# UNITED STATES PATENT AND TRADEMARK OFFICE

APPLICATION NO.	FILING DATE	FIRST NAMED INVENTOR	ATTORNEY DOCKET NO.	CONFIRMATION NO.
10/628,500	07/28/2003	Makoto Miyazawa	NEKU 20.544	5066
26304	7590	06/15/2006	EXAMINER	
KATTEN MUCHIN ROSENMAN LLP			NGUYEN, KHIEM D	
575 MADISON AVENUE			ART UNIT	
NEW YORK, NY 10022-2585			PAPER NUMBER	
			2823

## Office Action Summary

## DETAILED ACTION

**Fig. 3 PRIOR ART**

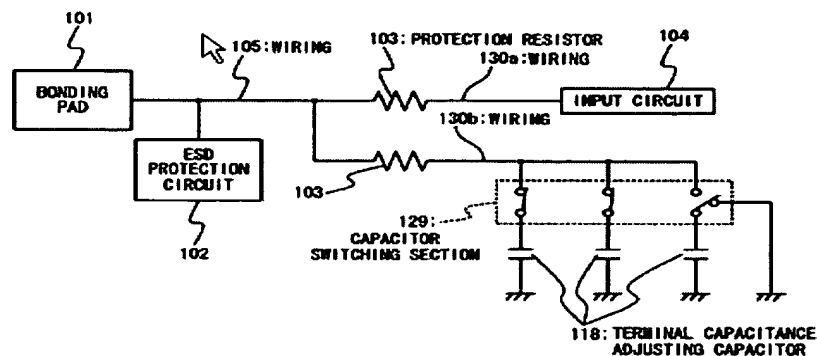
3. Claim 1 is rejected under 35 U.S.C. 102(b) as being anticipated by the Applicants' Admitted Prior Art (AAPA) in this application.

In re claim 1, AAPA discloses a semiconductor integrated circuit device comprising: a terminal 101; and a first capacitance adjusting section 129 which is connected to a wiring 105 between the terminal 101 and a protection resistor 103 in a front stage of an internal circuit 104; and a protection circuit 102 which is connected to the wiring 105 between the terminal 101 and the first capacitance adjusting section 129, the protection circuit 102 inherently protecting the internal circuit 104, wherein the first capacitance adjusting section 129 adjusts terminal capacitance of the terminal 101, based

on capacitance of the first capacitance adjusting section (AAPA, Background of the invention, Description of the Related Art in Pages 3-4 and FIG. 3).

FIG.2

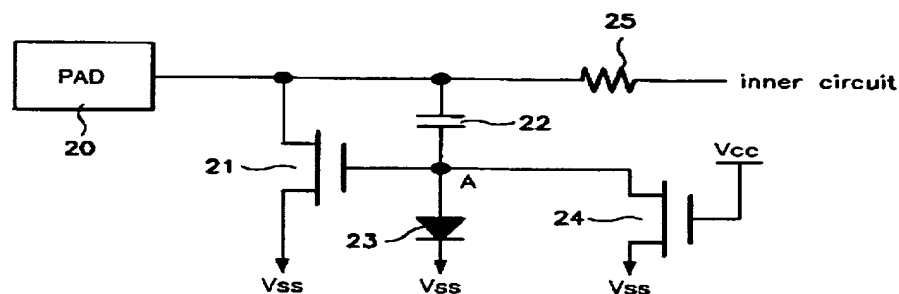
5. Claims 1, 3 and 7 are rejected under 35 U.S.C. 102(e) as being anticipated by Chang (U.S. Patent 6,611,407).

In re claim 1, **Chang** discloses a semiconductor integrated circuit device comprising: a terminal 20; and a first capacitance adjusting section 22 which is connected to a wiring (unlabeled) between the terminal 20 and a protection resistor 25 in a front stage of an internal circuit (inner circuit); and a protection circuit 21 which is connected to the wiring between the terminal 20 and the first capacitance adjusting section 22, the

protection circuit 21 inherently protecting the internal circuit, wherein the first capacitance adjusting section 22 adjusts terminal capacitance of the terminal 20, based on capacitance of the first capacitance adjusting section (col. 3, lines 28-56 and FIG. 2).

FIG.2

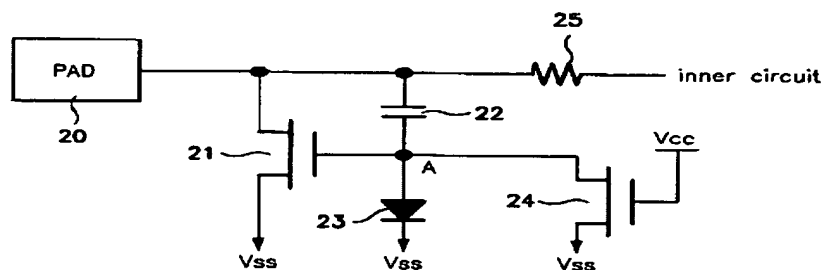
In re claim 3, Chang discloses a semiconductor integrated circuit device comprising: a terminal 20; and a first capacitance adjusting section 22 which is connected to a wiring (unlabeled) between the terminal 20 and a protection resistor 25 in a front stage of an internal circuit (inner circuit), wherein the first capacitance adjusting section 22 adjusts terminal capacitance of the terminal 20, based on capacitance of the first capacitance adjusting section, wherein the first capacitance adjusting section 22 comprises a first adjusting capacitor which adjusts the terminal capacitance (col. 3, lines 28-56 and FIG. 2), and
